SAFETY EVALUATION BY THE OFFICE OF NUCLEAR REACTOR REGULATION

SUPPORTING AMENDMENT NO. 31 TO

AMENDED FACILITY OPERATING LICENSE NO. R-37

THE MASSACHUSETTS INSTITUTE OF TECHNOLOGY

Figure 5 Isometric View of Fission Converter Tank Design

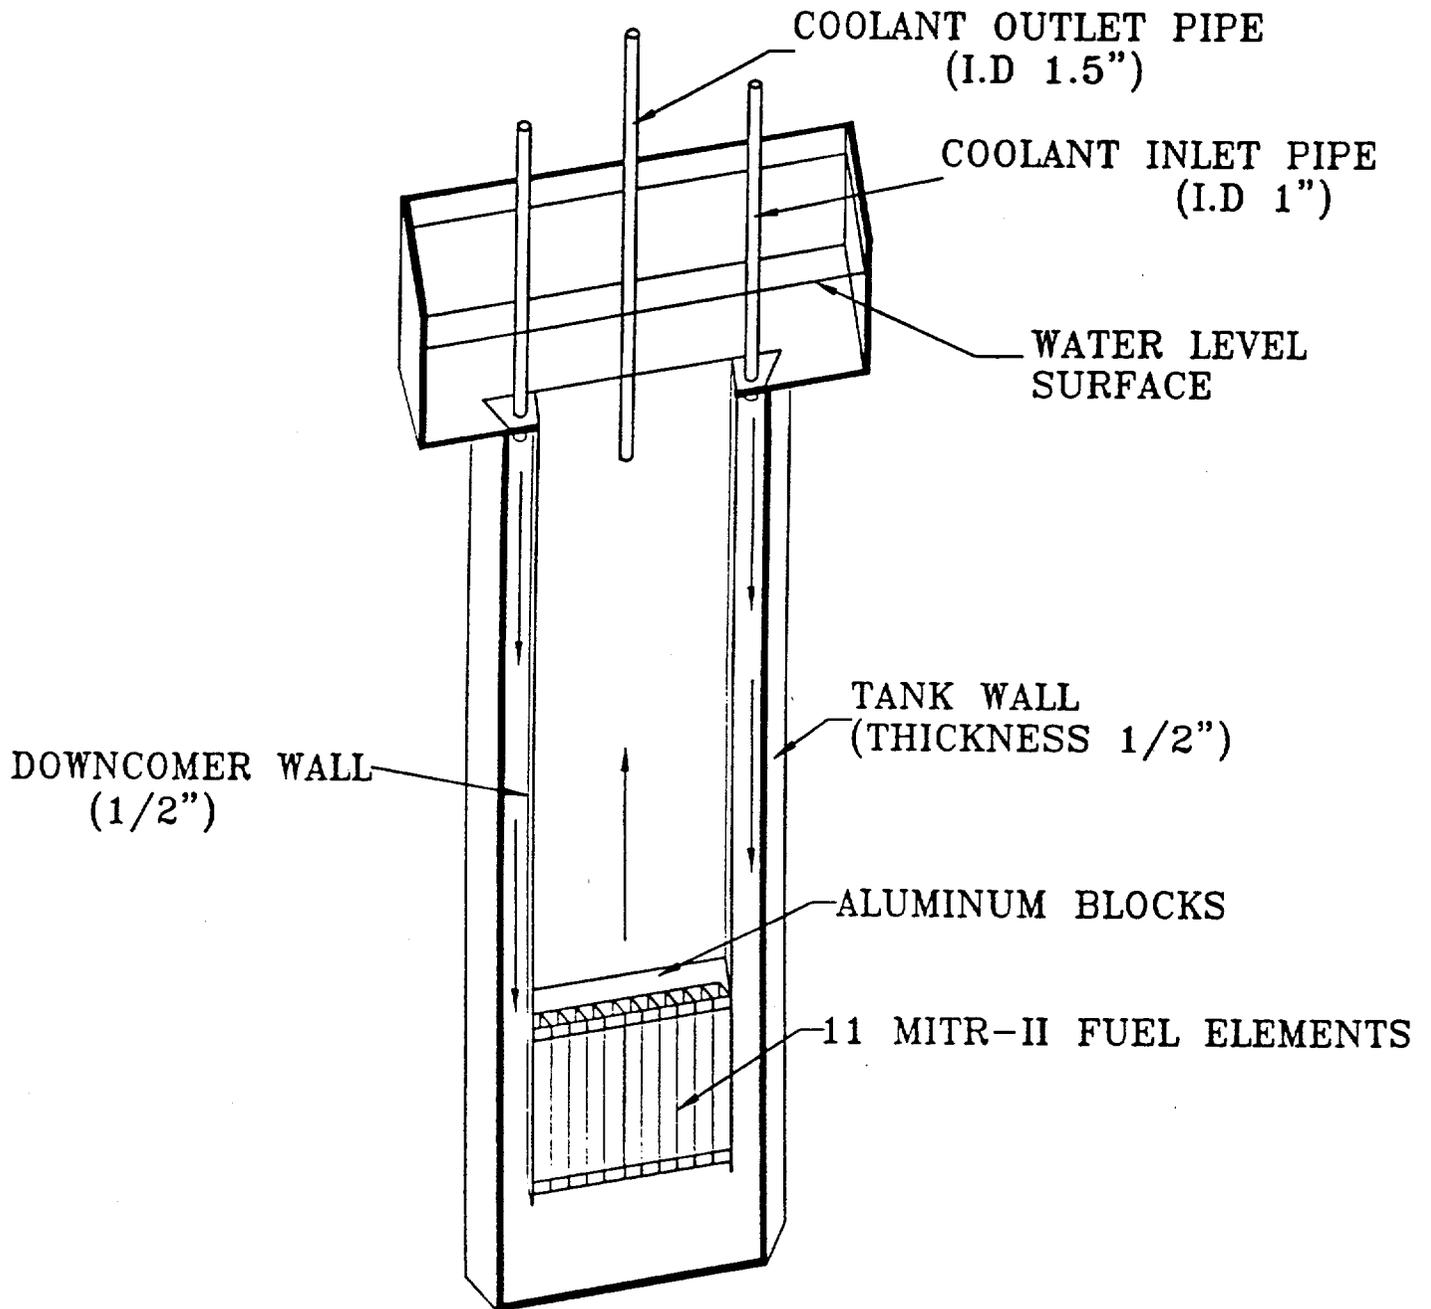
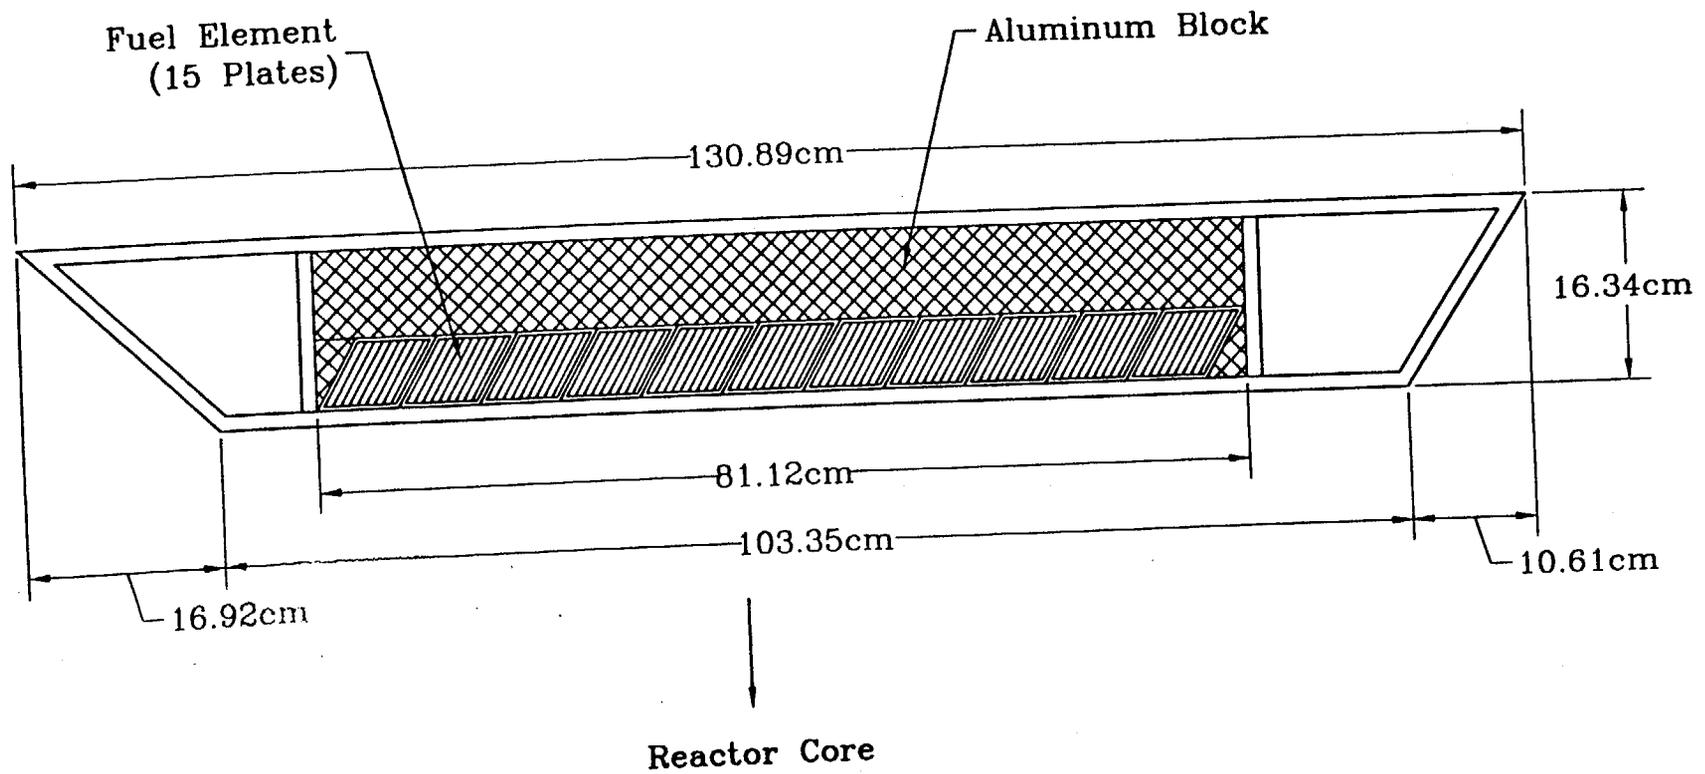
Figures 5 and 6 present an isometric and cross-sectional view, respectively, of the fission converter tank and the fuel location. It is possible to insert an aluminum block (that displaces the coolant/moderator near the fuel in order to improve the epithermal neutron beam) between the fuel and the converter tank wall. Proposed TS 6.6.4-5 requires the aluminum block to be installed unless calculations have been performed to show compliance with certain important design criteria with the block removed. Unless otherwise stated, the NRC staff's analyses and conclusions assume that the aluminum block is in place.

Figure 7 Schematic Drawing of Fission Converter Heat Removal System

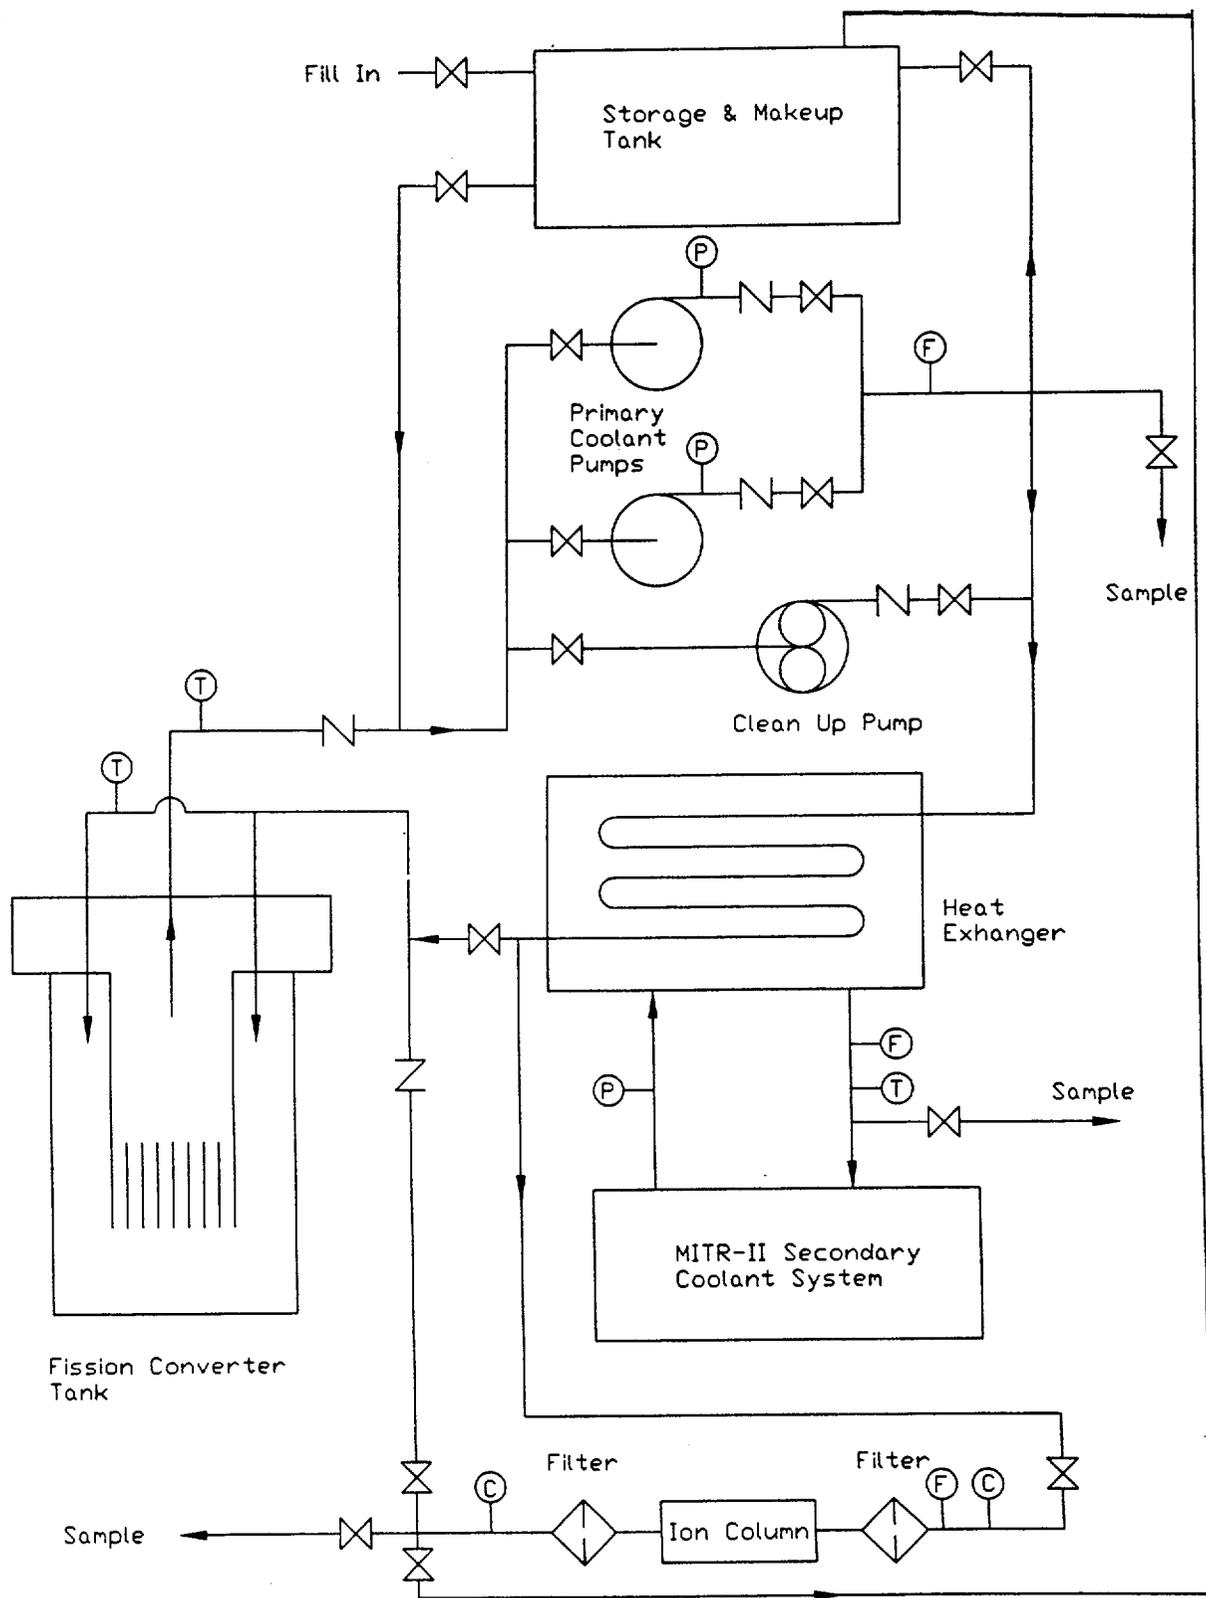
Figure 7 is a schematic drawing of the heat removal system of the fission converter. Also shown on this drawing are the ion exchange water clean up system and the makeup water system. Proposed TS 6.6.4-6 concerning design features of the cooling system requires that pumps and other components of the fission converter's primary cooling system be located to prevent uncovering of the fission converter fuel elements as a result of siphoning. Because it will help to ensure that the fuel elements remain covered with coolant, this TS is acceptable to the staff. The staff finds that the design of the cooling system meets this requirement.

Figure 8 Schematic Drawing of Fission Converter Cover Gas System

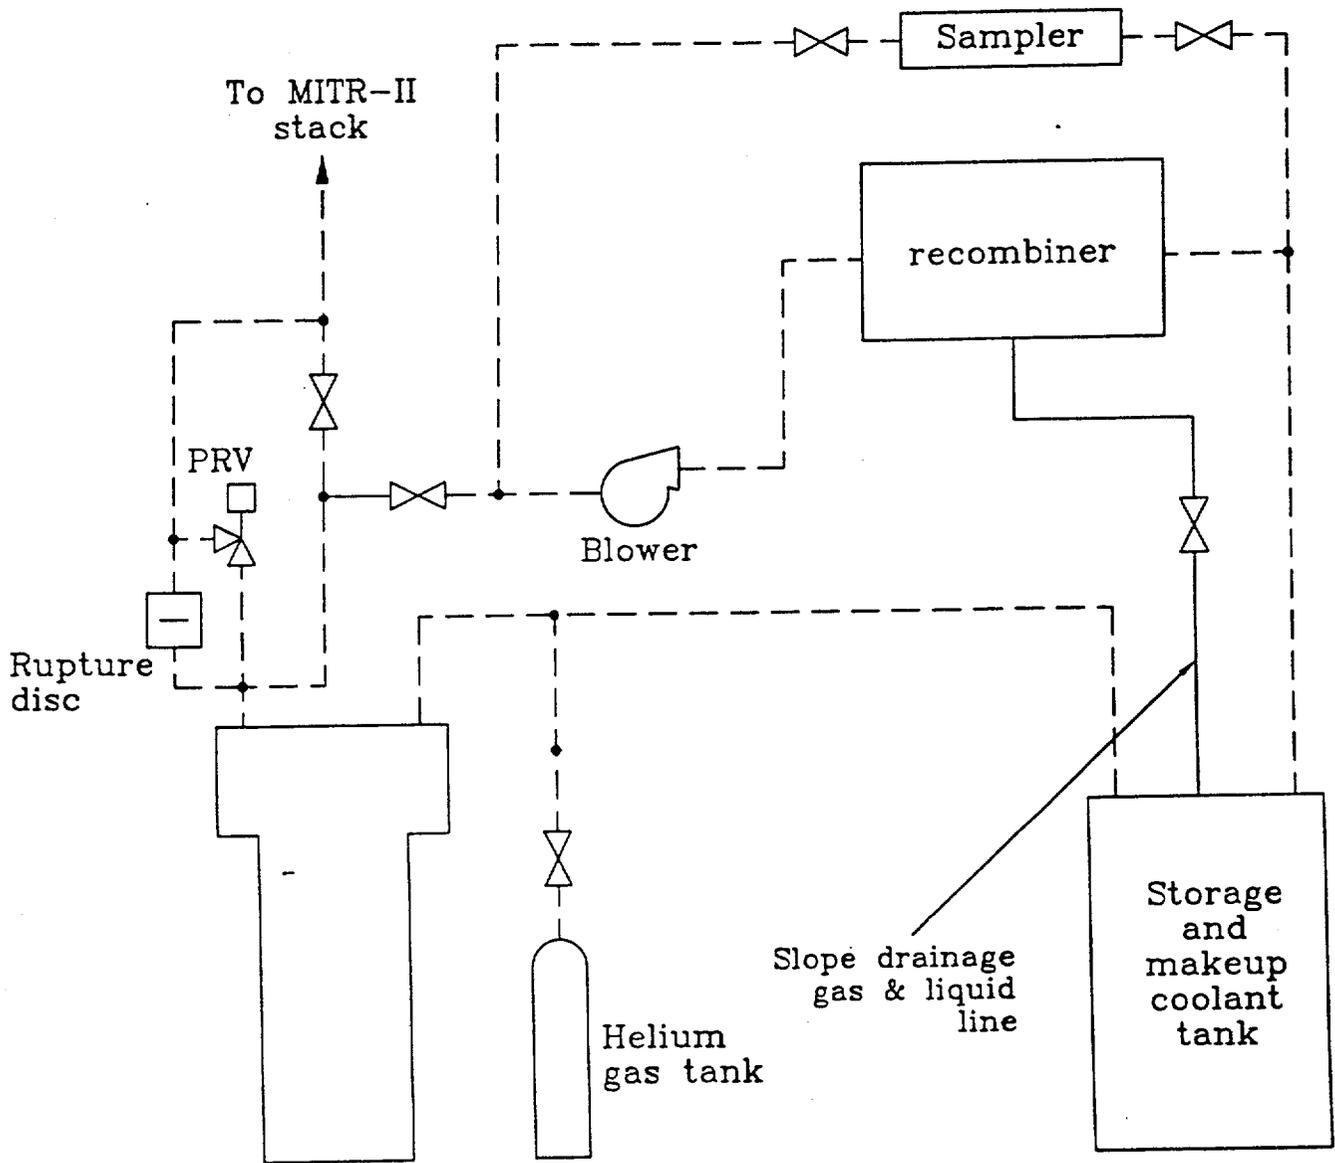
Figure 8 presents a schematic drawing of the helium cover gas system for the fission converter. The cover gas system has several important functions. These include maintaining the quality of the D₂O (if used), inhibiting the production of nitrous oxide, minimizing Argon-41 production, and providing a means to monitor for fission gases that would indicate a fuel element clad failure. An additional function is to provide an inert atmosphere for the circulation of radiolytic decomposition products through a recombiner. The conditions of operation of this recombiner are specified in proposed TS 6.6.2.4. This TS limits D₂ and H₂ concentration in the helium blanket to not exceed six volume percent, requires the recombiner to be operated for a minimum of five hours per month in any month that the converter was operated, and contains a requirement that if the recombiner is not operable, fission converter operation may continue as long as samples of the helium blanket are taken weekly and the D₂ or H₂ concentration in the helium blanket does not exceed two volume percent. The licensee has based operation and operating limits of the cover gas system on the similar system for the MITR which has been in use for many years without incident. The cover gas system is protected against over pressure with a relief valve and a rupture disk. The nominal relief setting of the valve and the nominal rupture pressure of the disk will be 4 psig and 5 psig respectively. The licensee states that the fission converter tank will be tested to 10 psig.

The staff reviewed the description of the cover gas system that the licensee is proposing. The design is based on the considerable incident free experience with a similar system used with the MITR. The pressure testing of the system and the use of the proposed over pressure protection is additional conservatism in the design. For these reasons the design as proposed by the licensee is acceptable to the staff.

Figure 13 Fission Converter Water Shutter System

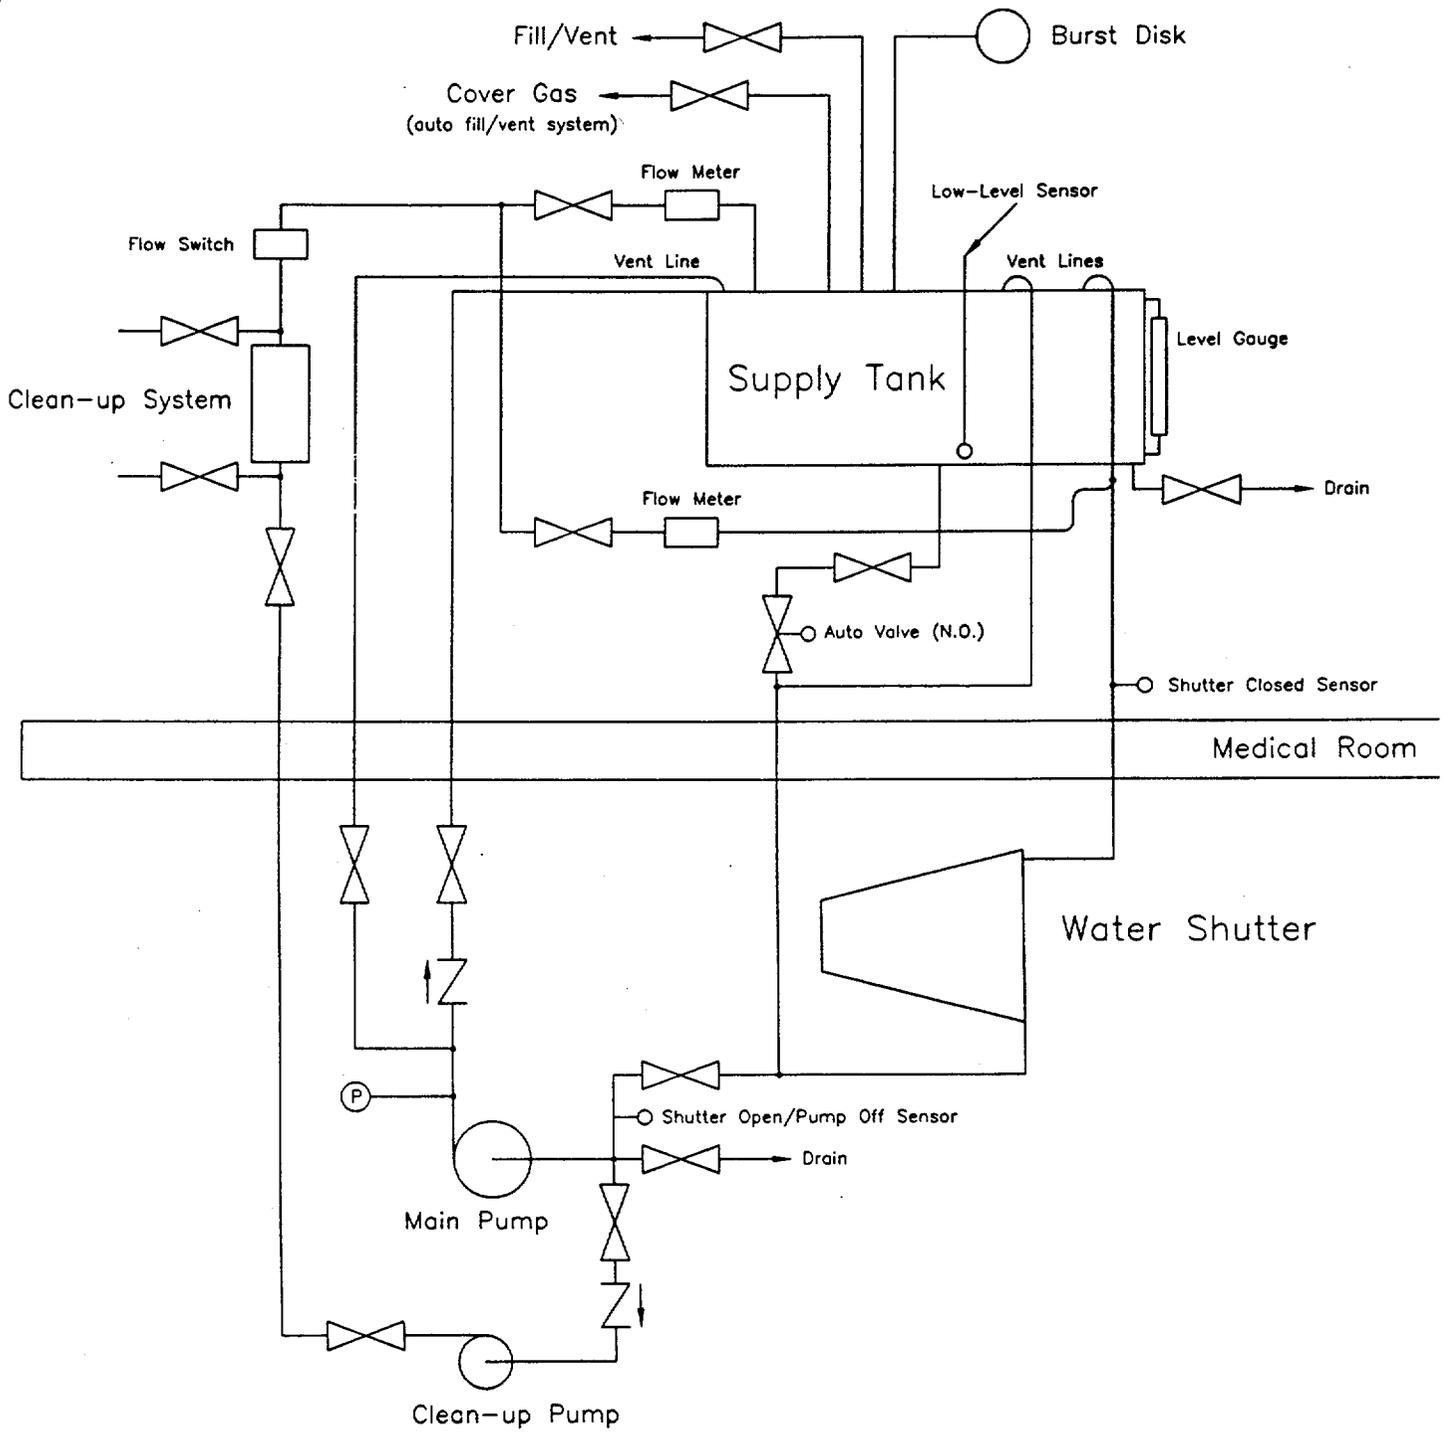
The water shutter is located in the collimator and provides neutron and gamma ray attenuation. Figure 13 presents a schematic of the water shutter control system.

The normal non-energized position of the controls creates a closed (full) shutter. To open the shutter, a valve must be closed and water pumped from the shutter to the storage tank. The shutter refills by gravity. Opening or closing the shutter will take less than 120 seconds. That time was chosen for operational efficiency only and not for safety considerations. Interlocks are provided to ensure that the shutter closes automatically when the medical therapy room door is opened or the MCRP Key Switch is turned to the OFF position. The full open or full closed positions are indicated on the MCRP.

The water shutter is one of three redundant shutters that "stop" the beam. This shutter closes (floods) by gravity with loss of off site power. The staff concludes that the water shutter is not reactor safety significant and will not have a significant reactivity effect on the reactor. The staff finds that the proposed water shutter design is acceptable.
